Authors' response for AMT-2014-243 "MAX-DOAS observations of aerosols, formaldehyde and nitrogen dioxide in the Beijing area: comparison of two profile retrieval approaches" by T. Vlemmix et al.

In this document we will answer to the questions asked by the referees, and indicate how this lead to changes in the revised version of the manuscript. The original comments by the reviewers were copied to this document and printed in italics. Referee comments are given numbers as C1.2 for the second comment by referee #1. The authors' response (**AR**) is written as normal text, and indicated by **AR**. Pages and lines in the original (AMTD) manuscript are referred to as 'OM p. X, l. Y' (for instance, OM p.9675, l. 17).

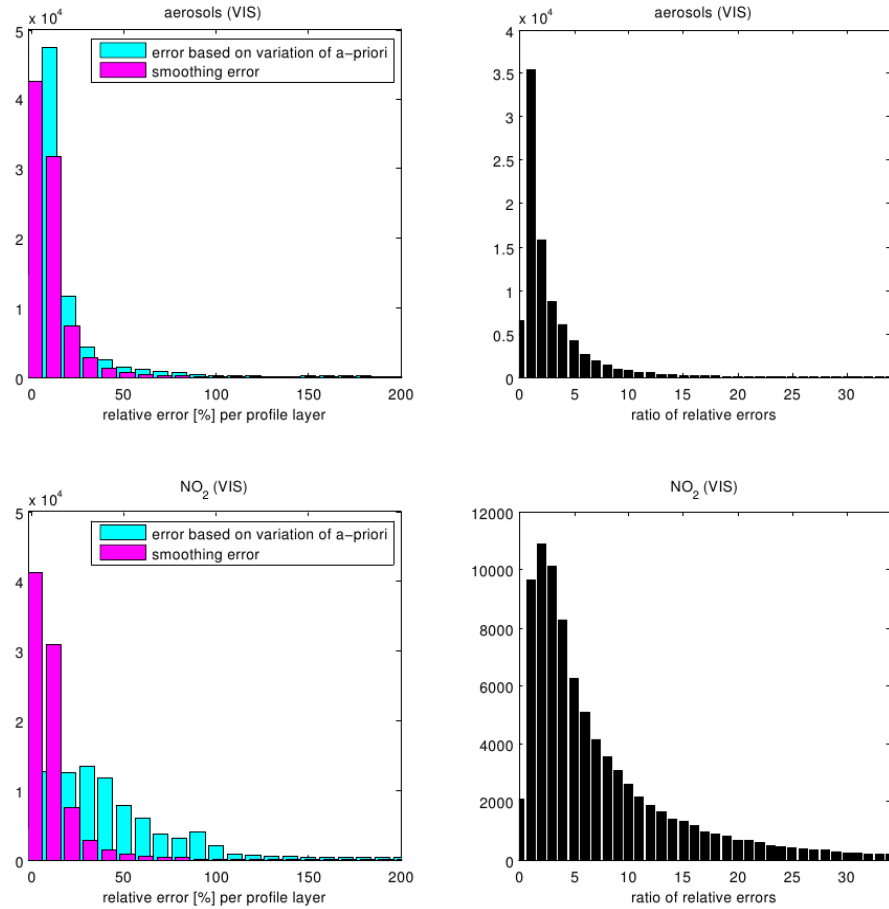
C 1.6: *P. 9682, 1st paragraph: How does the uncertainty calculated in this way compare to the smoothing error that can be obtained from the optimal estimation framework?*

After this interesting question by the referee, a numerical comparison (based on all retrievals performed in 2011) has been performed of the a-priori based error (described above) and the smoothing error. For the aerosol retrieval as well as the trace gas retrieval it was found that the relative a-priori based error is almost in every case larger than the relative smoothing error. In 80% of all aerosol retrievals, the relative a-priori based error is up to 4 times larger than the relative smoothing error (median ratio is 1.6). In 80% of all trace gas retrievals, the relative a-priori based error is up to 12 times larger than the relative smoothing error (median ratio is 4.8), see also Fig. 1 of this document.

"Tests have indicated that errors estimated in this way are in general considerably larger than the smoothing error, a commonly used parameter in the optimal estimation framework to quantify the impact of the a-priori on the retrieval error (Rodgers, 2000). The relative smoothing error per layer is typically less than 20%, for both the aerosol extinction and the trace gas retrieval. The a-priori based error is about 1.6 times higher in case of the aerosol extinction retrieval and about 4.8 times higher in case of the NO₂ retrieval (both numbers are median values)."
